ADDENDUM NO. 1

Date of Addendum: 01/23/2024

PROJECT NAME: *611 Walker Mitigation-Hurricane Harvey*

PROJECT NO: WBS No. D-200006-0001

SHEET NO.:
AD102

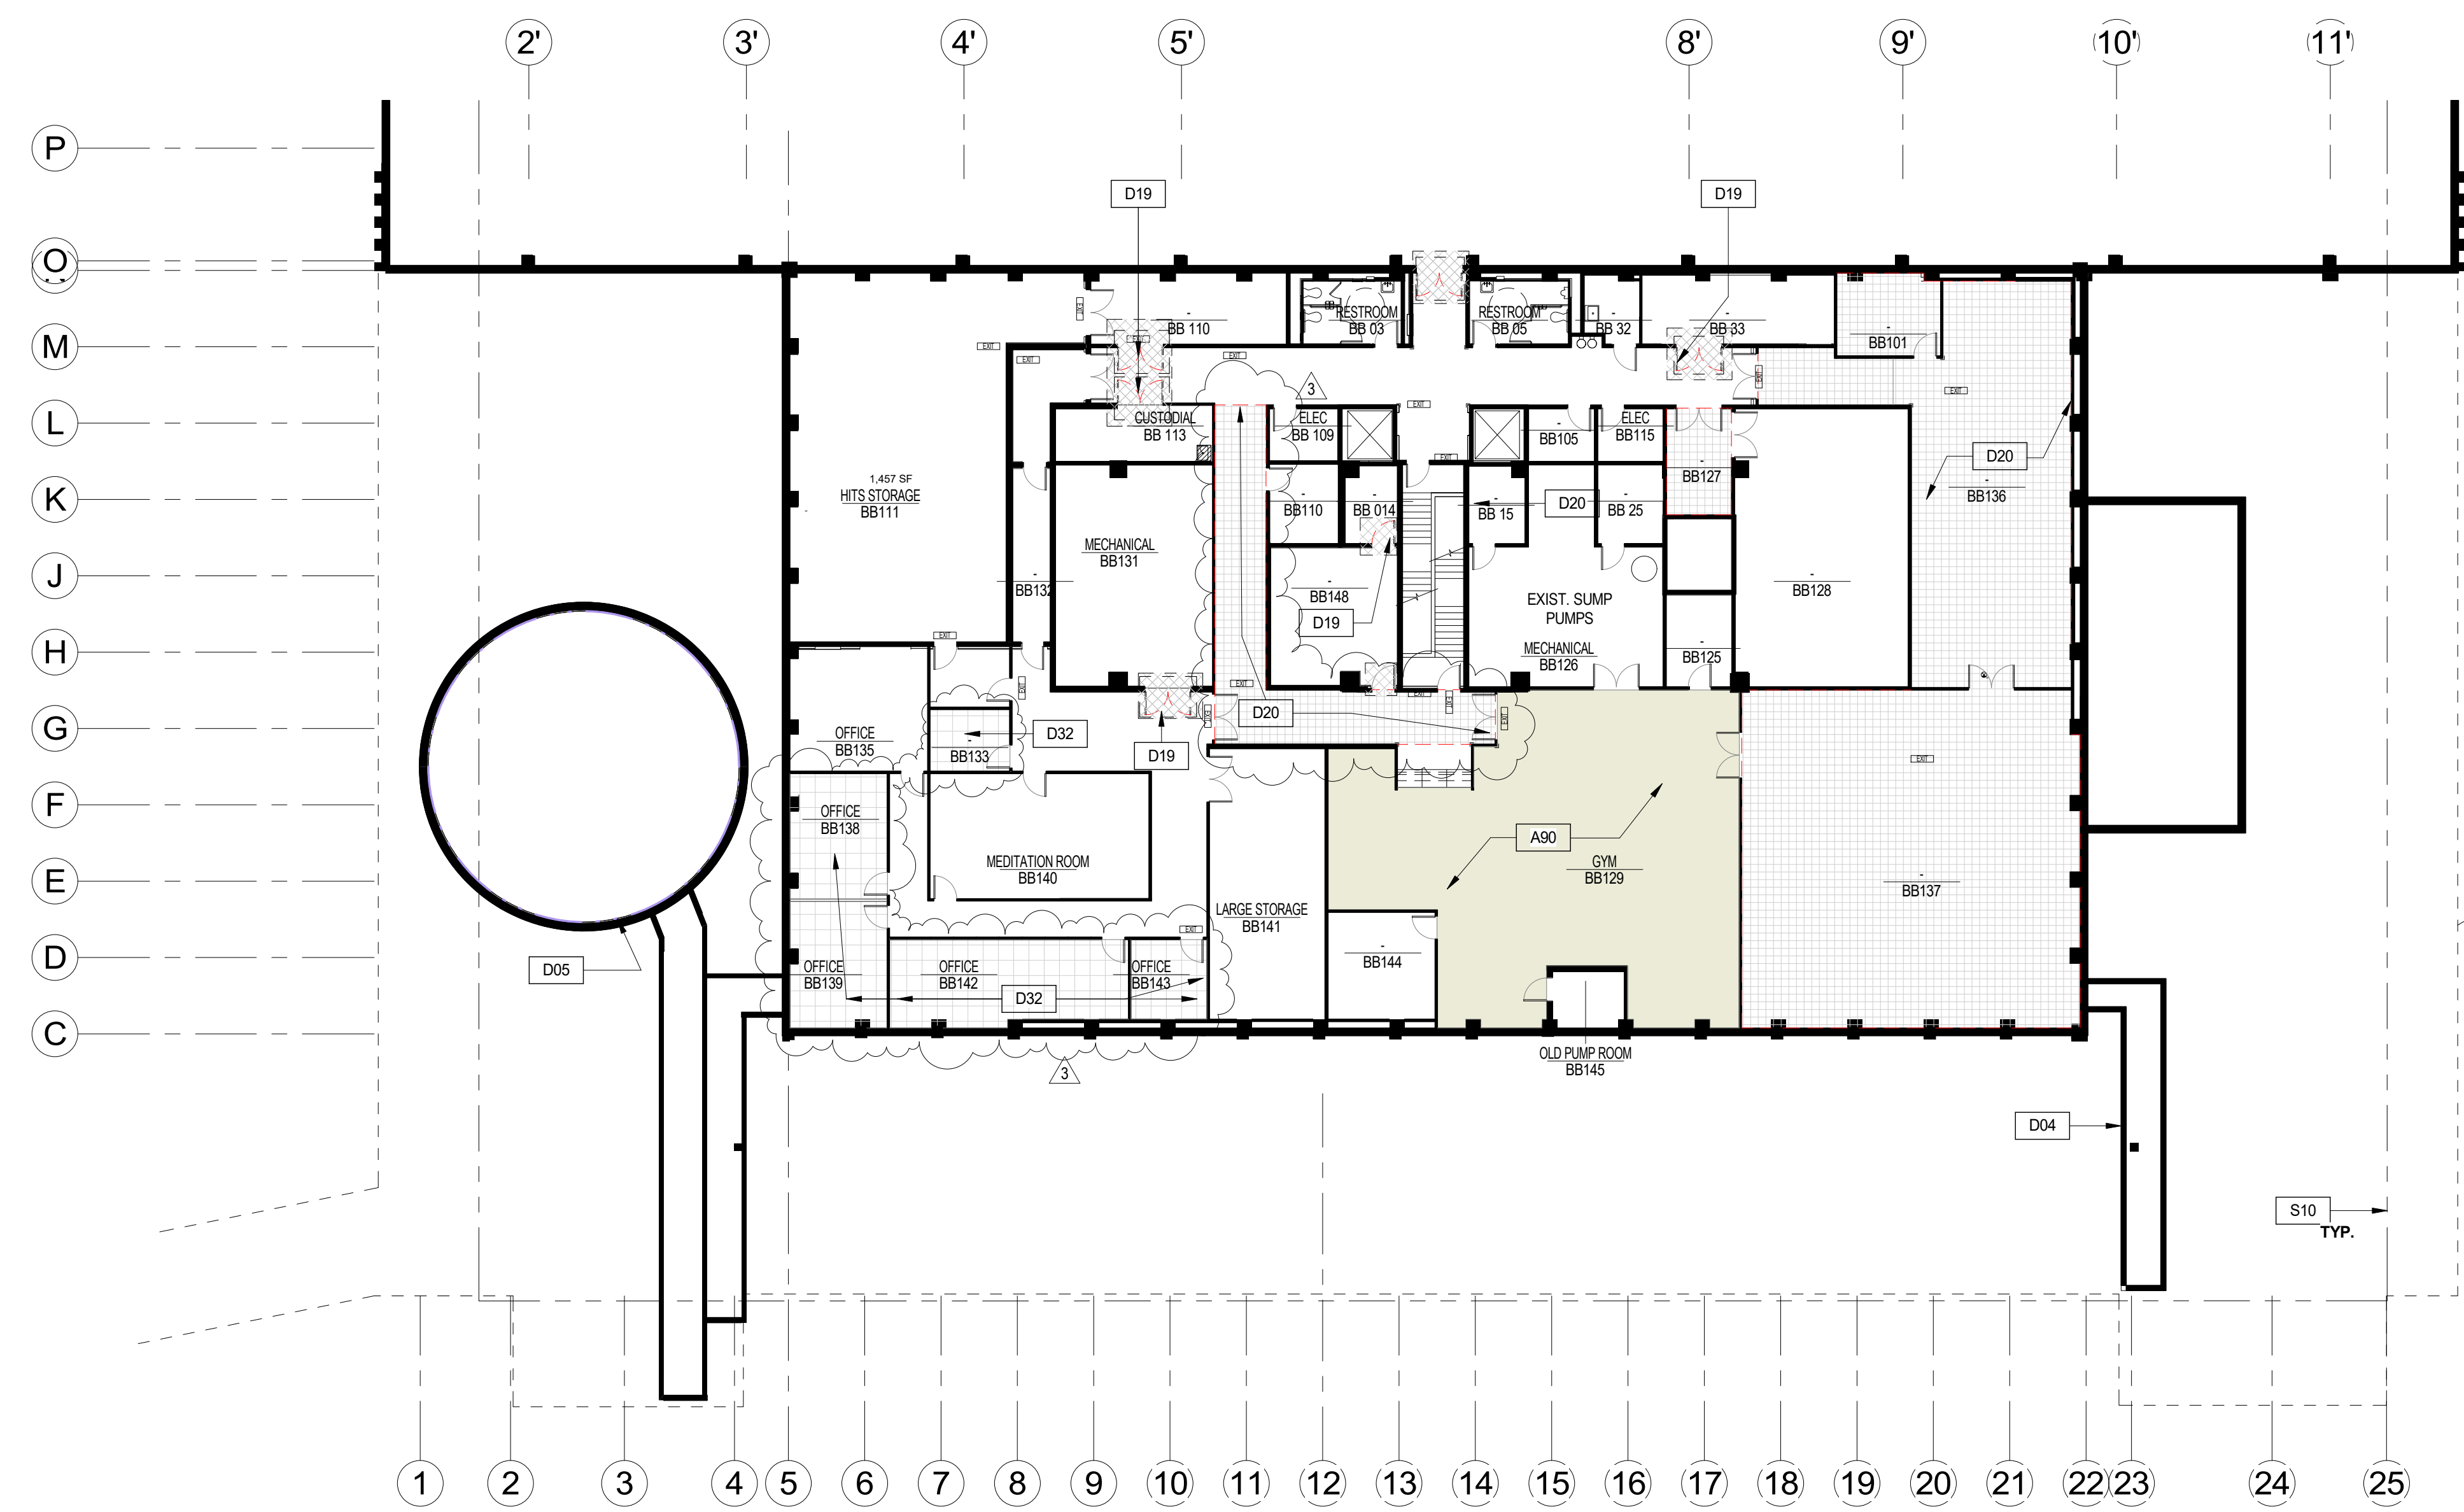
1. Delete Sheet AD 102 – Architectural Demolition Plan-LVL-B2 dated May 23, 2023, and replace with attached sheet AD 102-Architectural Demolition Plan-LVL-B2 dated January 22, 2024.
2. Delete Sheet A 101 – Architectural Floor Plan-LVL-B1 dated May 23, 2023, and replace with attached sheet A 101 – Architectural Floor Plan-LVL-B1 dated January 22, 2024.
3. Delete Sheet A 640 – Door & Window Schedule, Types & Notes dated May 23, 2023, and replace with attached sheet A 640 – Door & Window Schedule, Types & Notes dated January 22, 2024.

2. RFI Question #2: Please see attached drawing of B1 and B2, Yellow are areas where there is no existing flooring. Red is area that I was not able to access. Do you want any flooring or base done in these areas? If you do, please let me know what type. Carpet or VCT.

Response: Please refer to sheet AD 101 and 102 for the floor demolition scope and refer to sheet A 101 and 102 for the area that will require new flooring and base. On LVL B1-The 2 offices on the north side (B103 & B108) are to receive new VCT. On LVL B2 – See updated sheet AD 102 and A 640 for additional information.
